123 DC - 195 Duncan Creek Rd., Lillington, NC 27546

PLAN 1 The Clayton - LH 'FRENCH COUNTRY' ELEVATION

10-22-24- Redlines - JJ

THE CLAYTON - LH
Cover Sheet 'French Country'

SCALE:
1/8" = 1'-0"
SHEET
1.2.1b

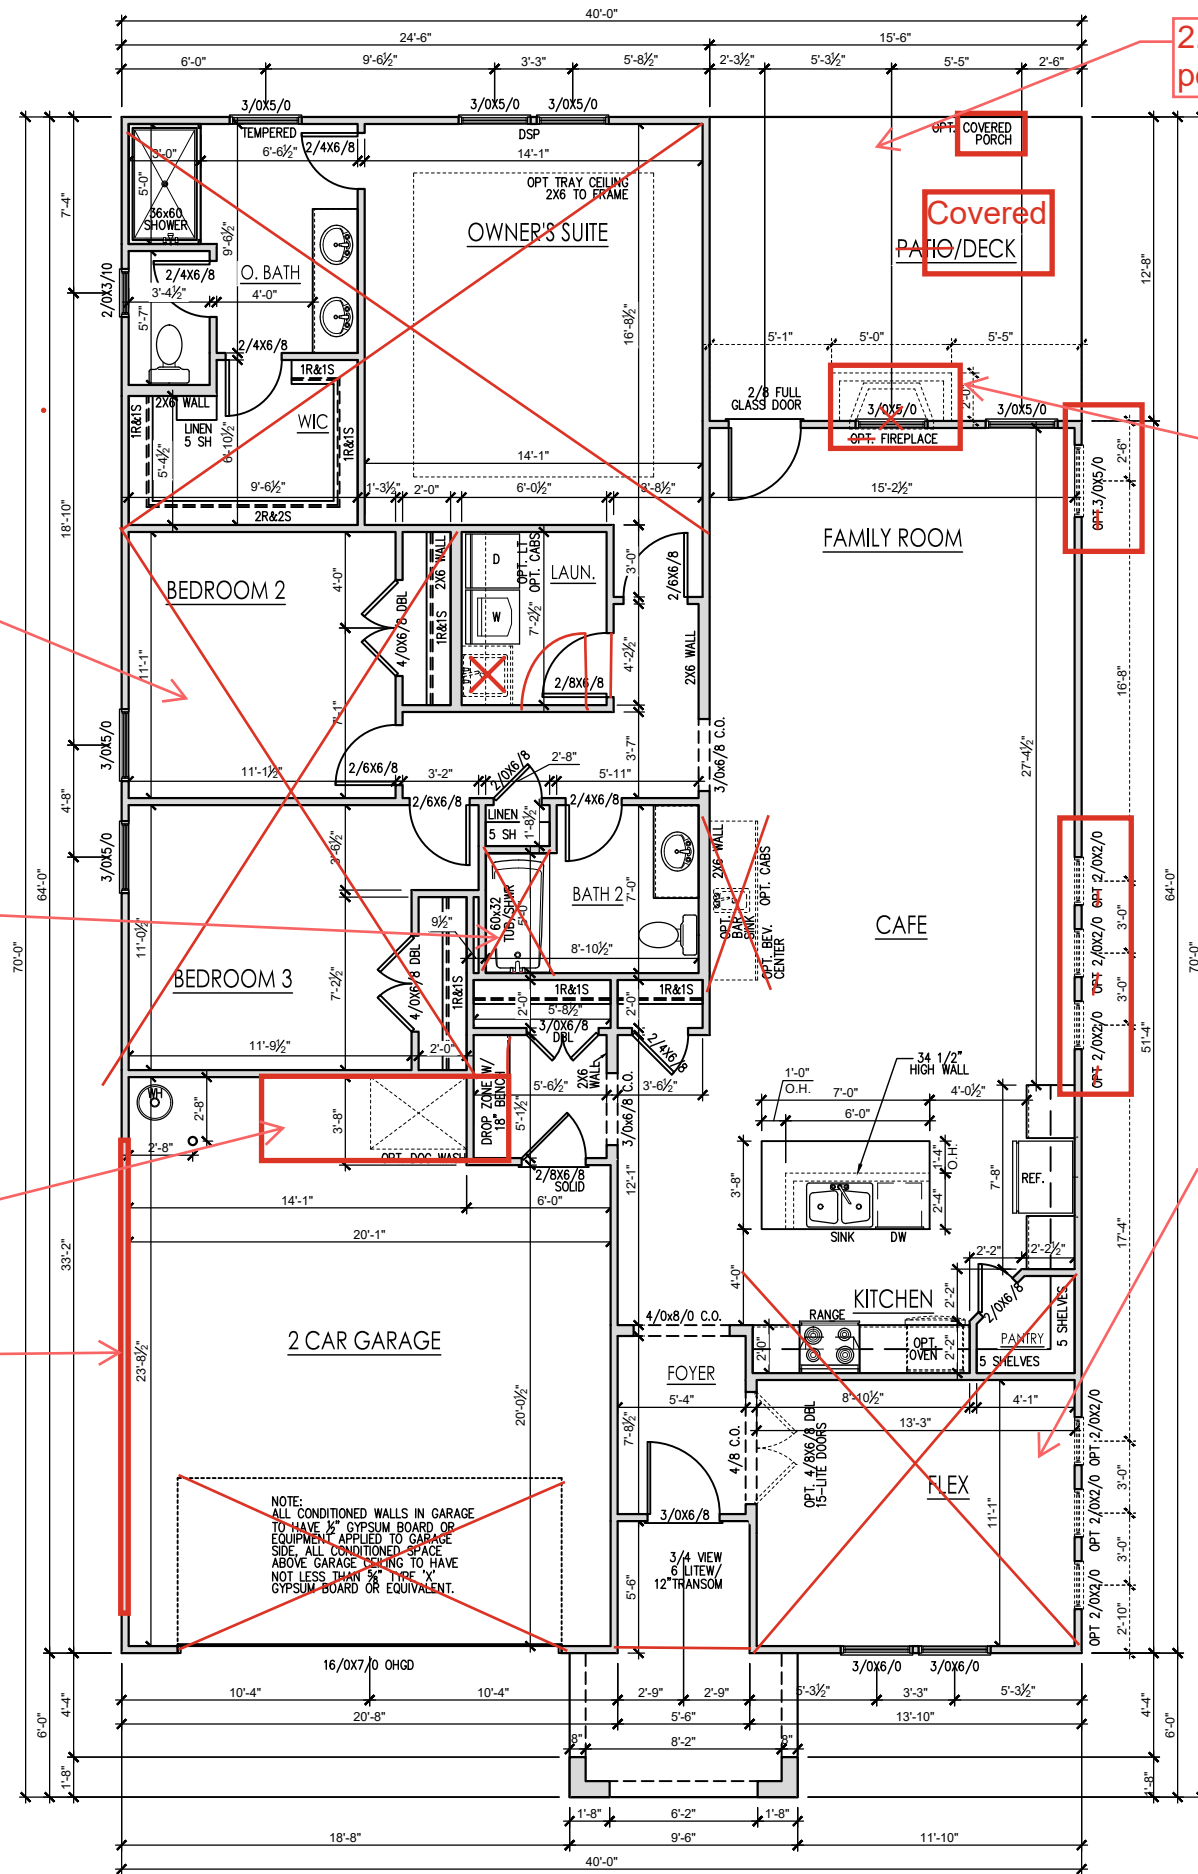
1.2.1b - side load garage

1.2.1b - smart door delivery

1.2.1b - fireplace

SCALE:
1/8" = 1'-0"
SHEET
2.1b

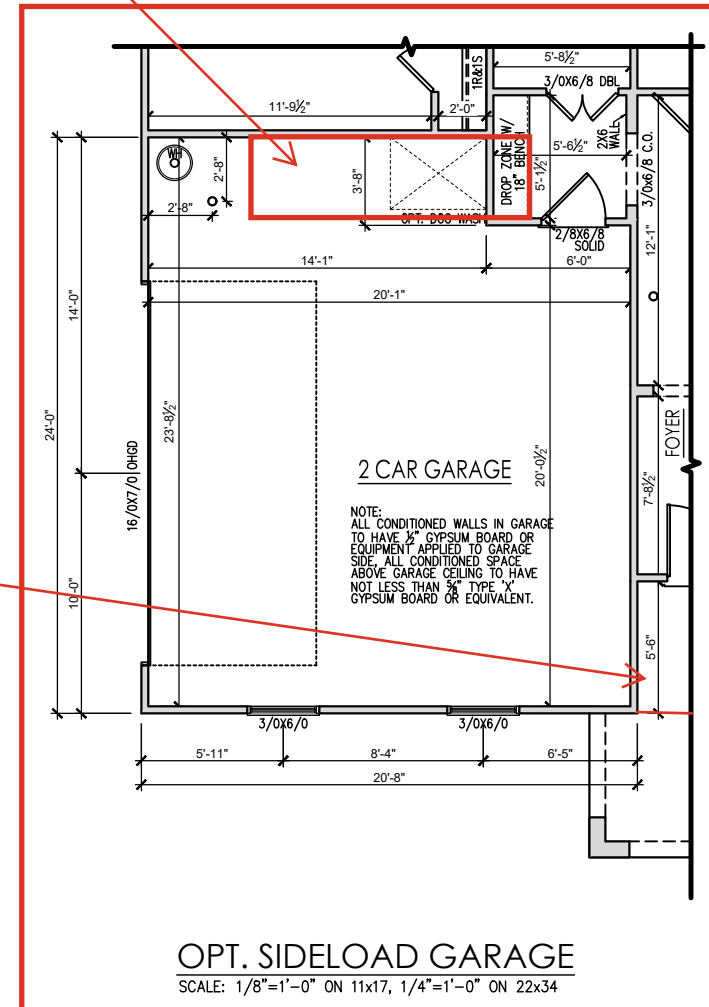
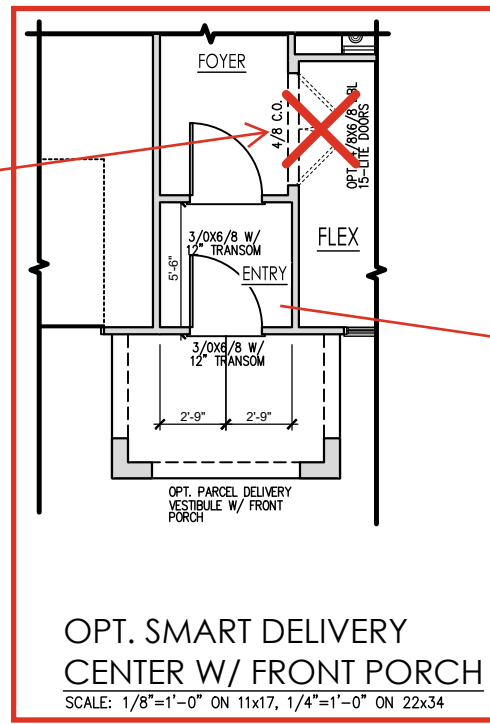
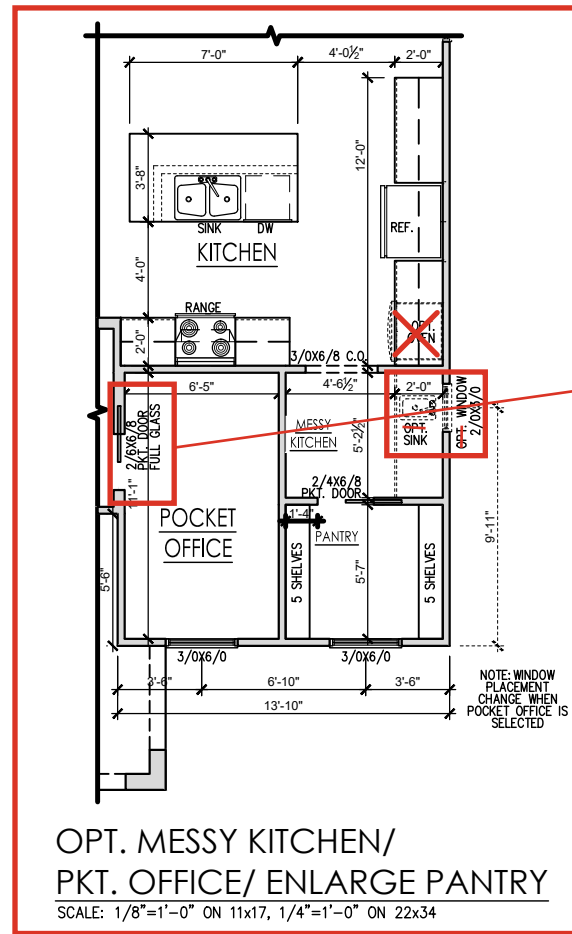
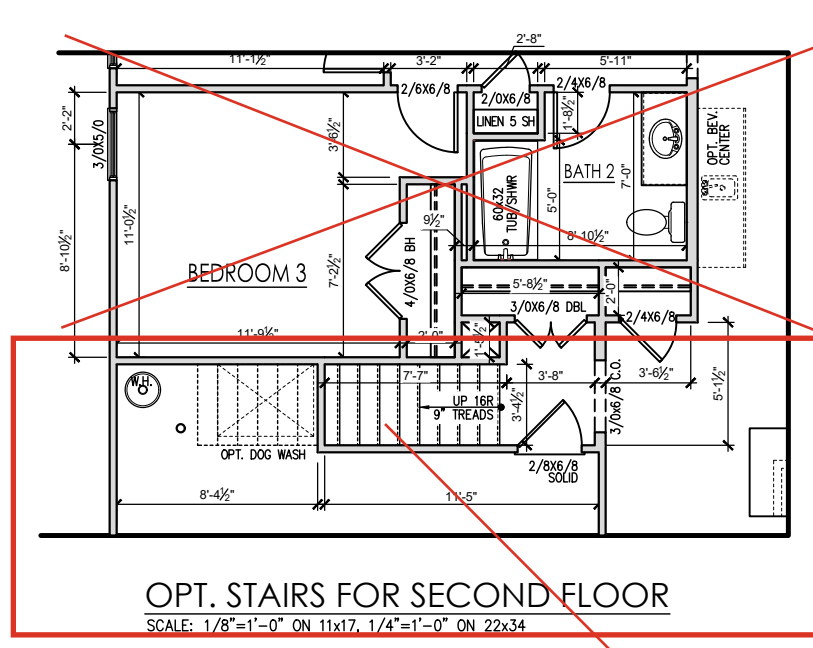
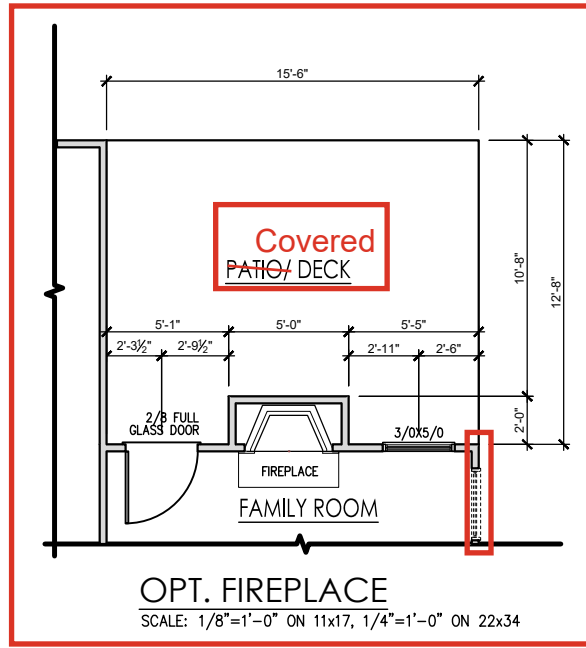
2.4.1b - covered porch

2.1.1b - family room fireplace

2.1.2b - owner's suite with extended WIC, Tub & shower w/ seat, bedroom 2, laundry

2.1.1b - stairs to 2nd floor

2.1.1b side load garage

2.1.1b - messy kitchen. pantry, pocket office & smart door delivery

SCALE:
1/8" = 1'-0"
 SHEET
2.1.2b

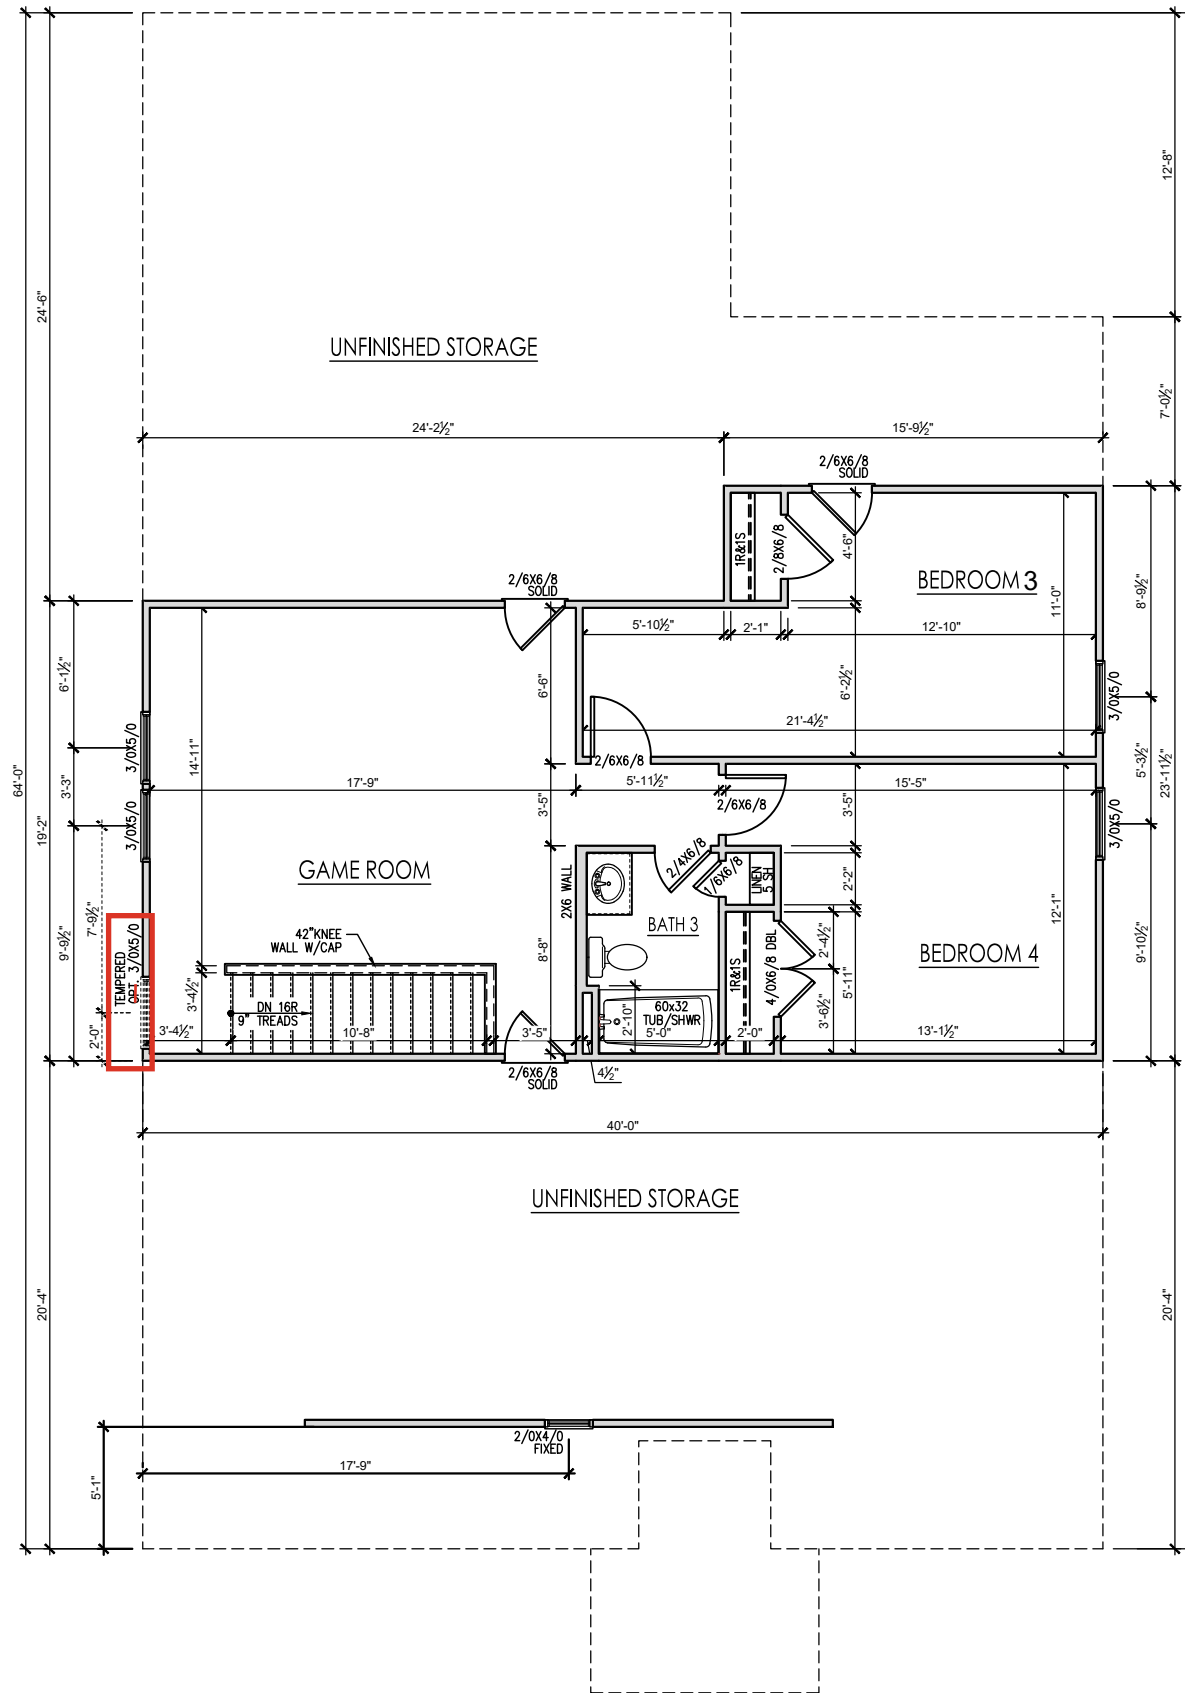
2.1.1b- Stairs

SHEET
2.4.1b

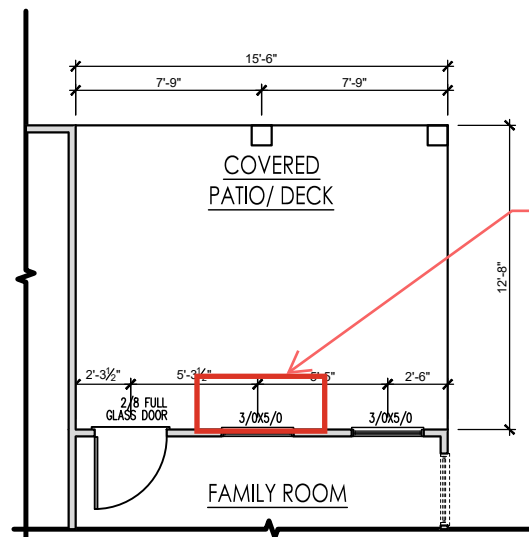
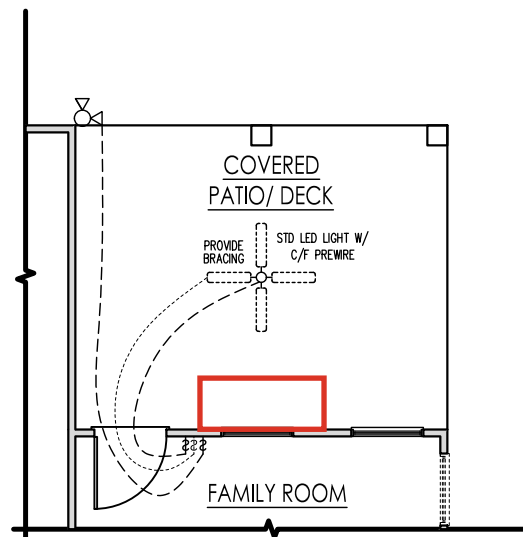
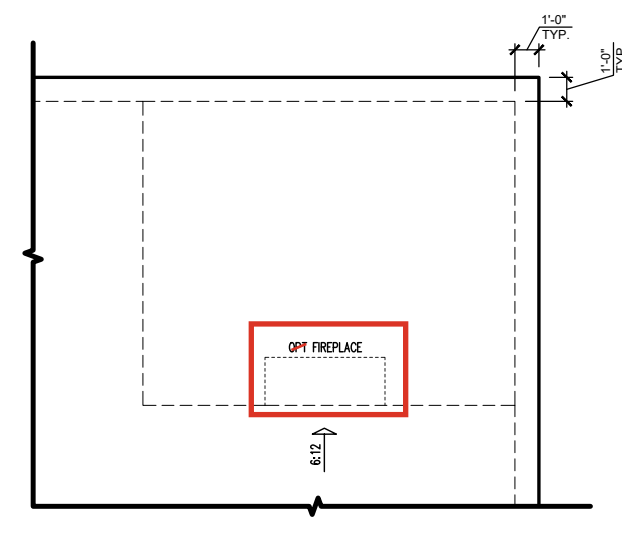
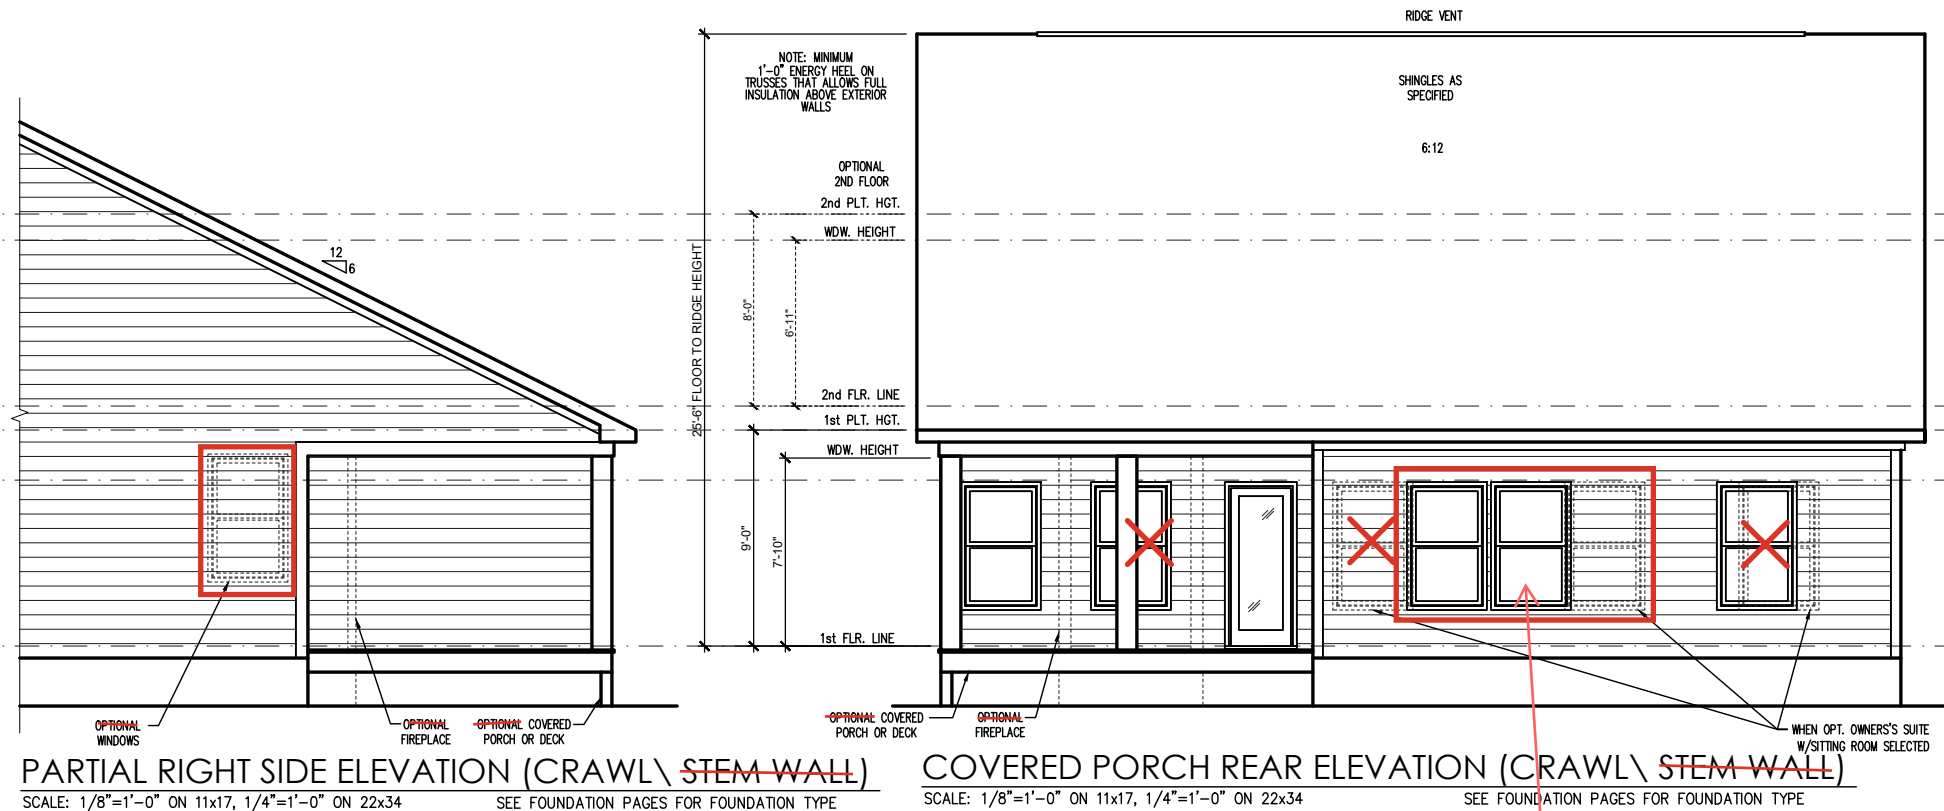
2.1.1b - fireplace

3.1.1b- owner's suite windows

FRONT ELEVATION 'FRENCH COUNTRY' (CRAWL/STEM WALL)
SCALE: 1/8"=1'-0" ON 11x17, 1/4"=1'-0" ON 22x34 SEE FOUNDATION PAGES FOR FOUNDATION TYPE

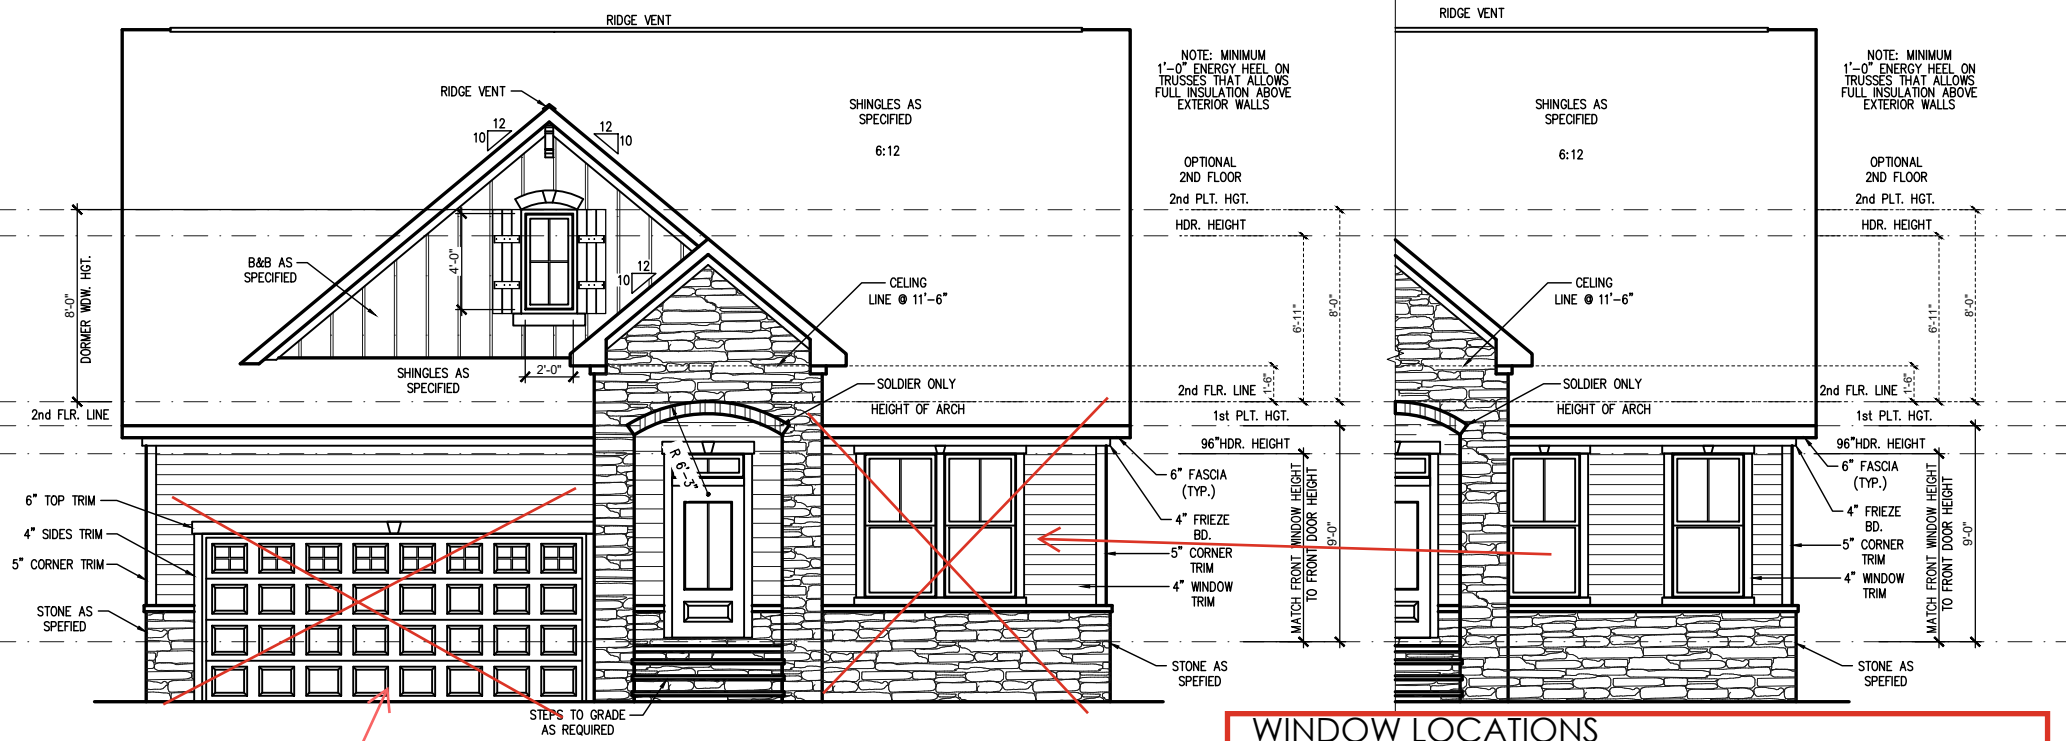
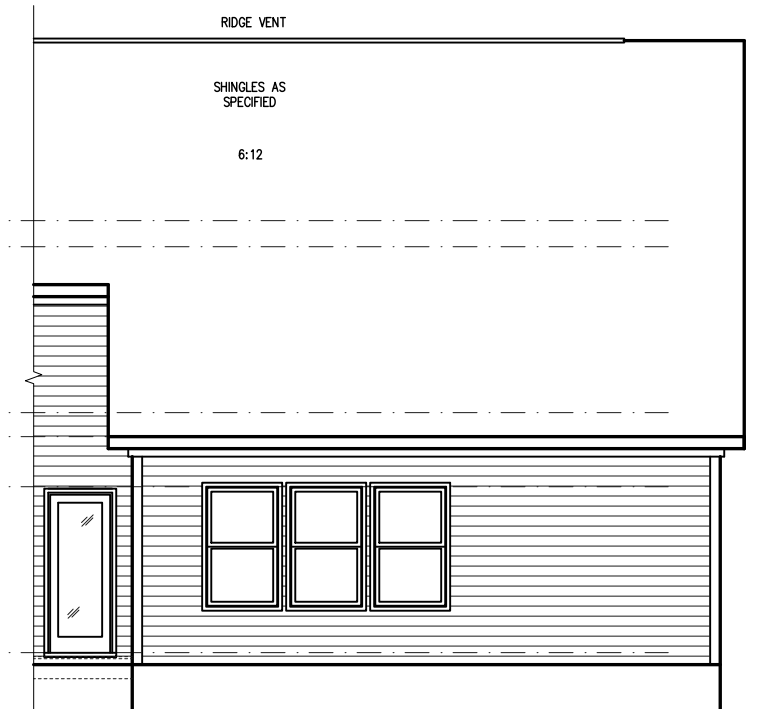
3.3.1b- side load garage front elevation
